Part 1 General

- .1 This addendum consists of two pages plus the following list of drawings:

1.2 CHANGES TO THE PROJECT MANUAL

1.3 CHANGES TO DRAWINGS

- .2 DRAWING E1 – ELECTRICAL NEW CONSTRUCTION

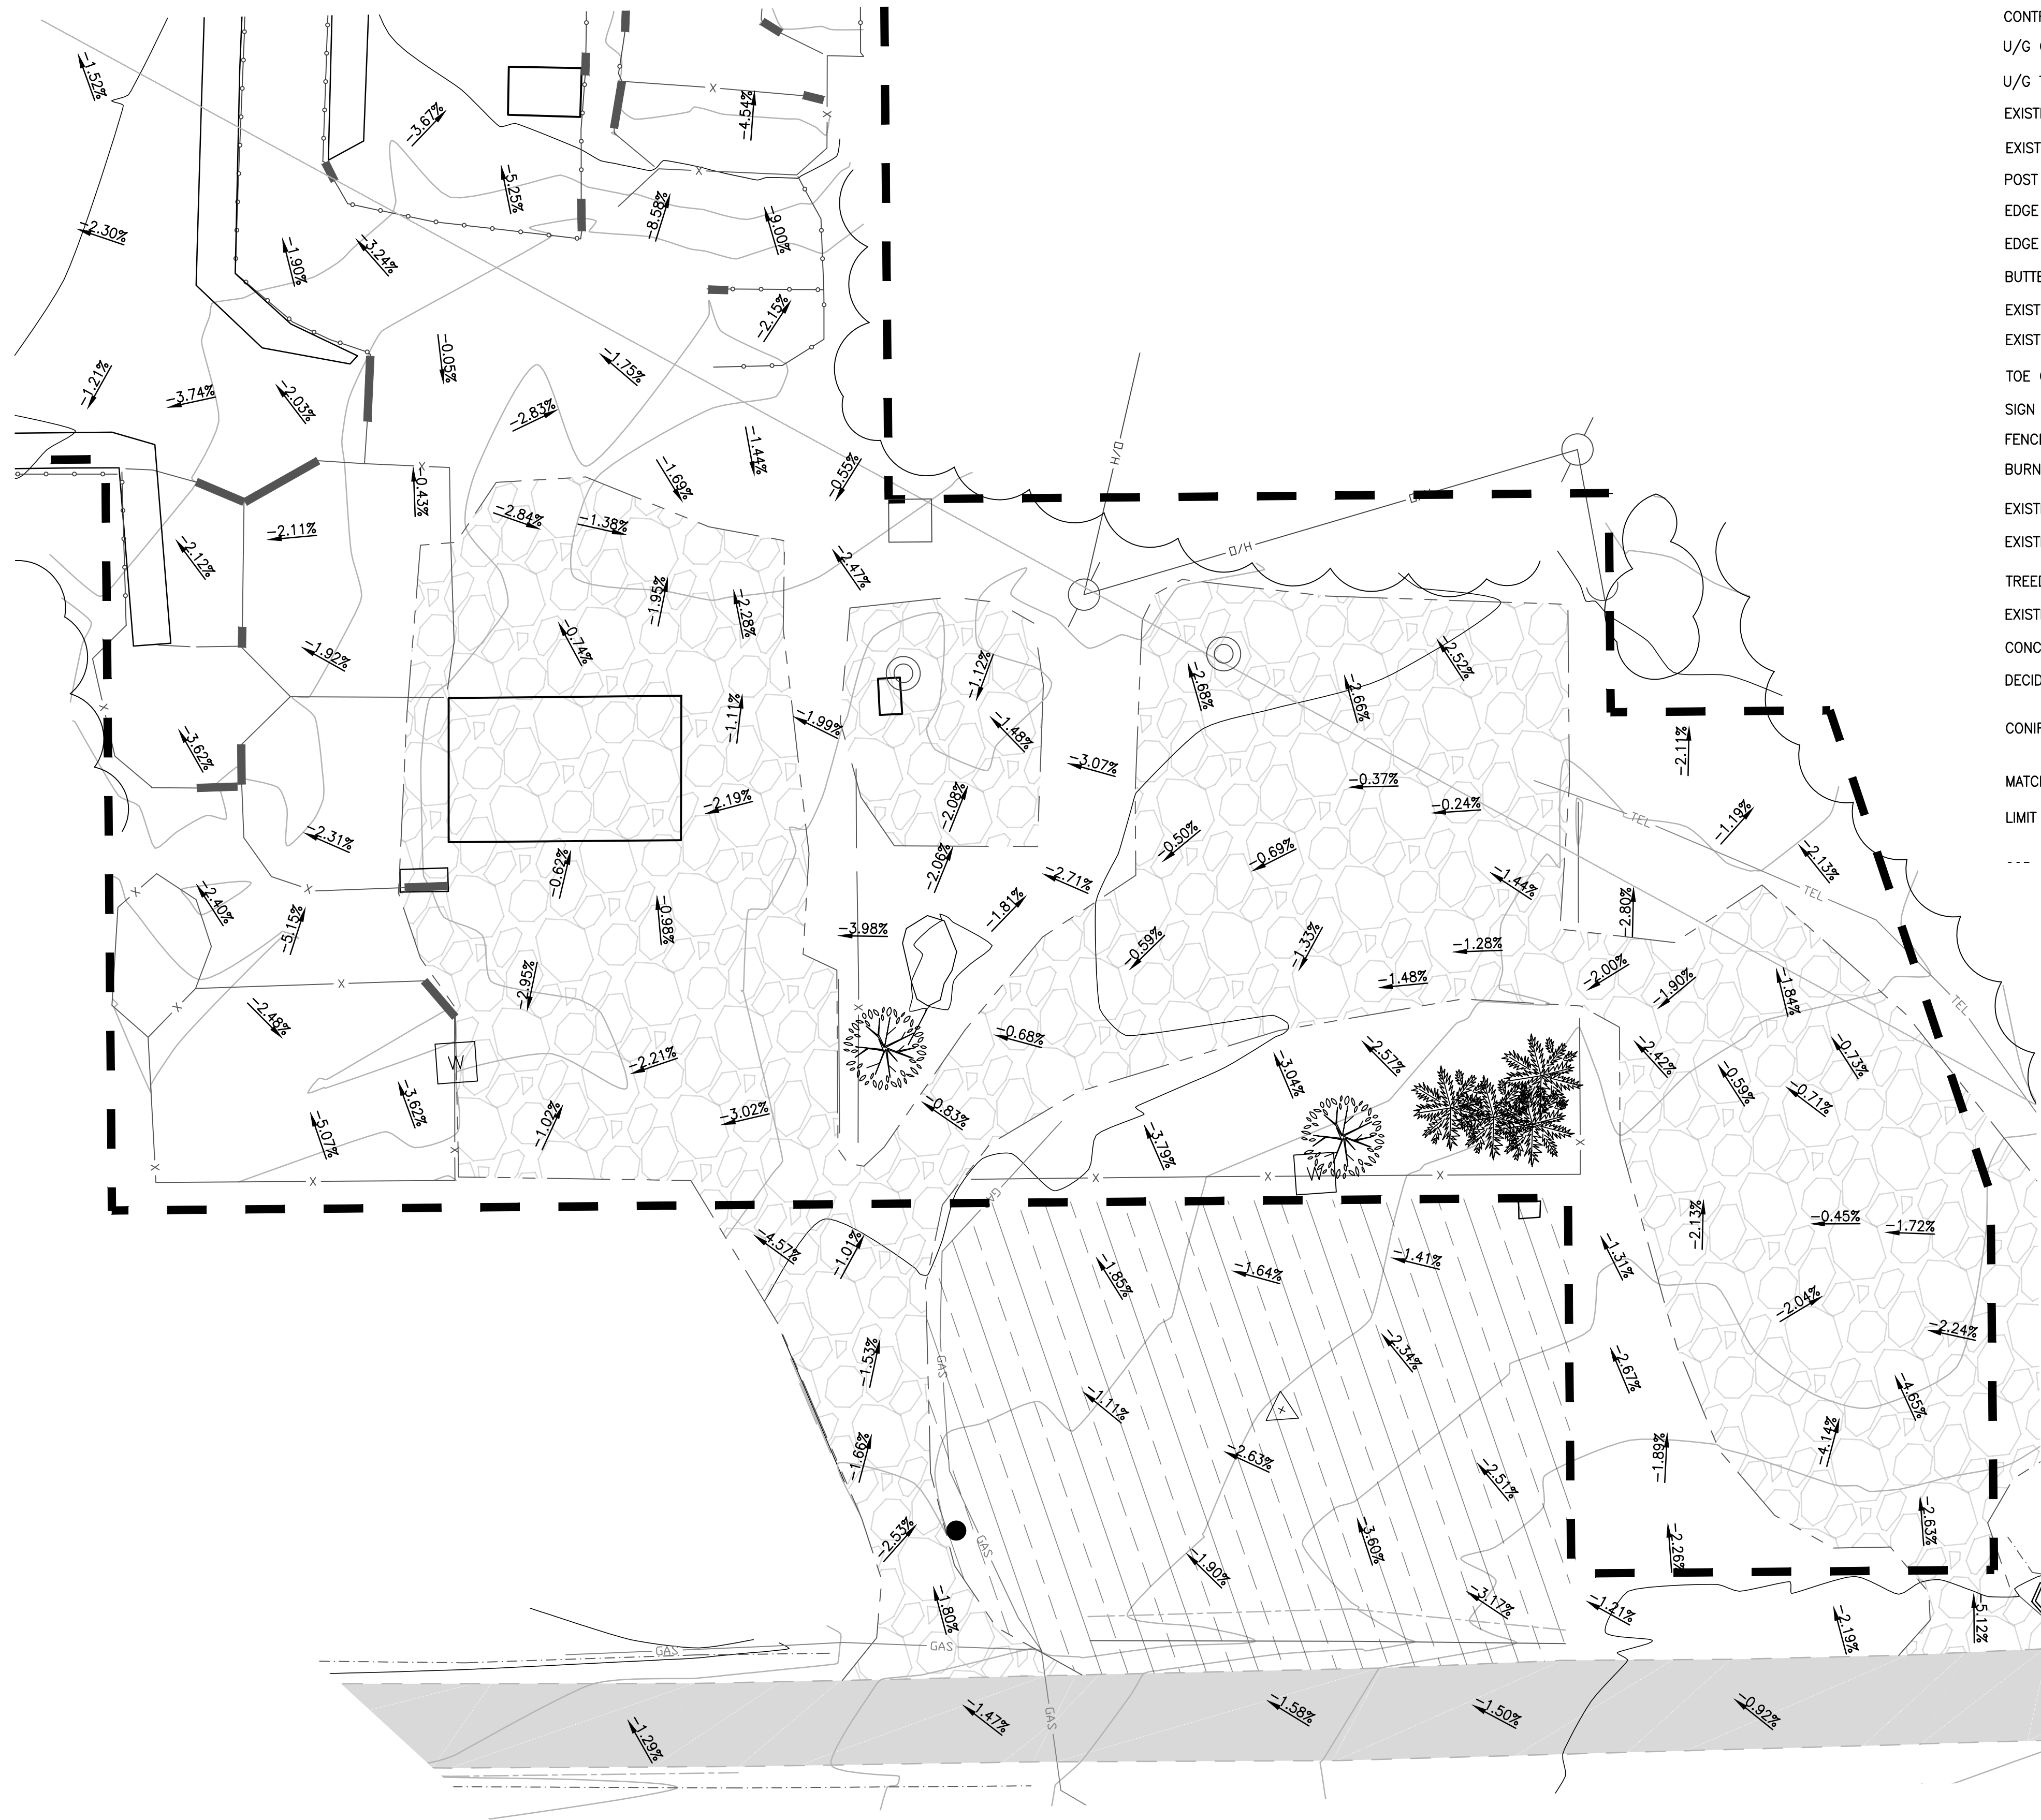
- .1 Refer to revised Drawing E1 as attached. Revisions are indicated in revision clouds.

Project no R.096286.001	Drawing no S6 OF	Revision no 0
-----------------------------------	--------------------------------------	-------------------------

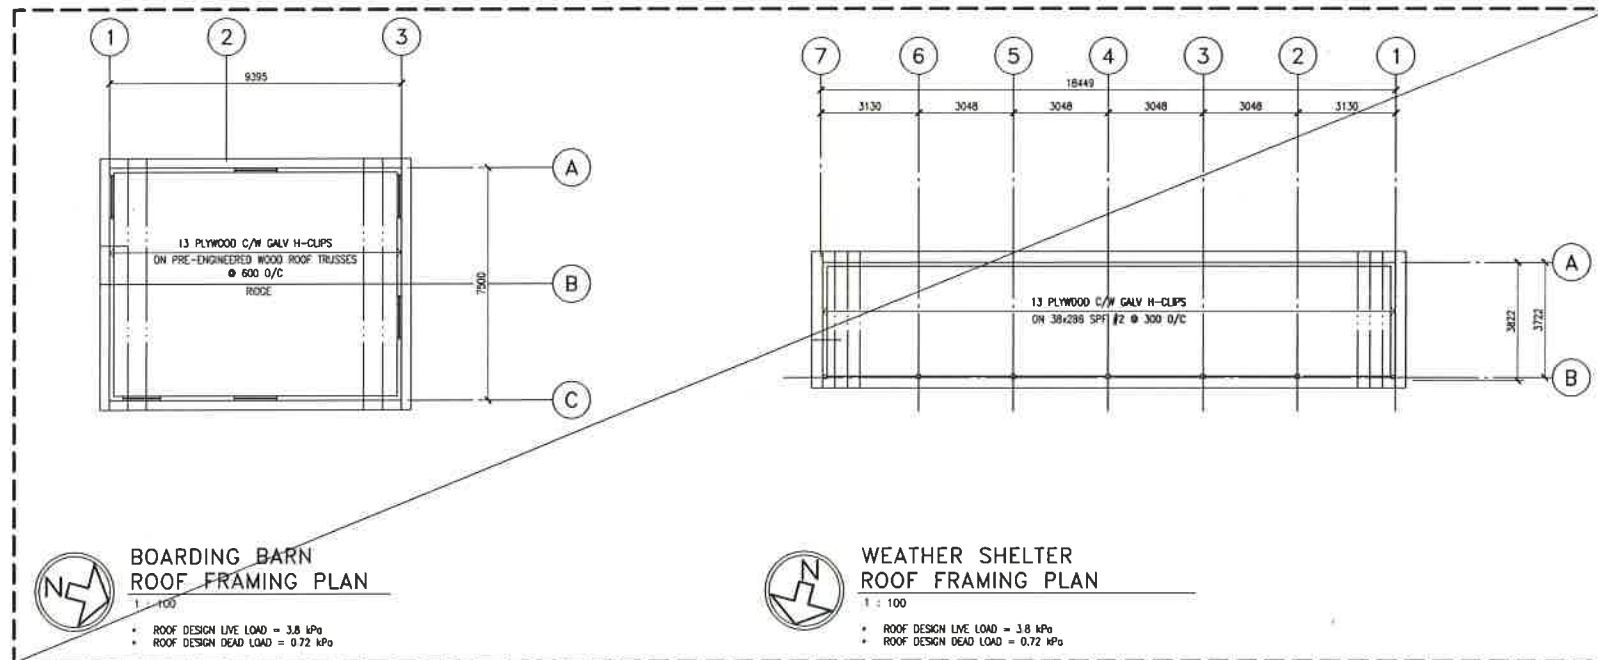
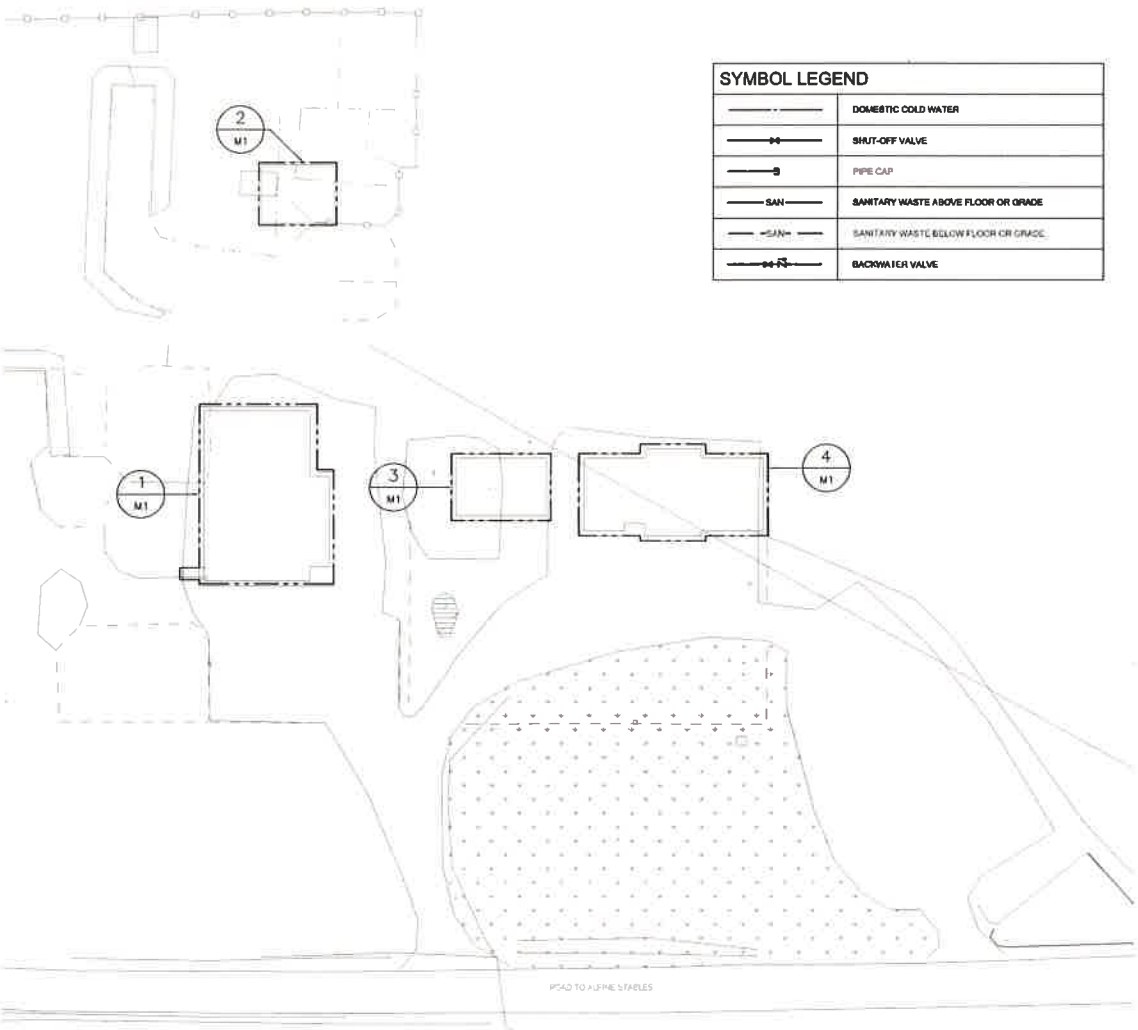
- .1 DRAWING S6 – FOUNDATION SECTIONS

- .1 **Expand** top of slab/floor elevation to include Finished Floor Elevations (FFE) as indicated on Civil drawings:

.1 Sections 1/S6, 2/S6, and 7/S6: Top of slab elevation for Saddling Barn 100 000 (FFE = 1290.37).

.2 Sections 3/S6 and 4/S6: Top of floor elevation for the weather shelter 99 345 (FFE – 1289.70).

.3 Sections 5/S6 and 6/S6: Top of floor elevation for the bunk house and alpine cottage 100 155 (FFE – 1290.66).

.4 Sections 8/S6 and 9/S6: Top of floor elevation for the boarding barn 99 760 (FFE 1290.11).
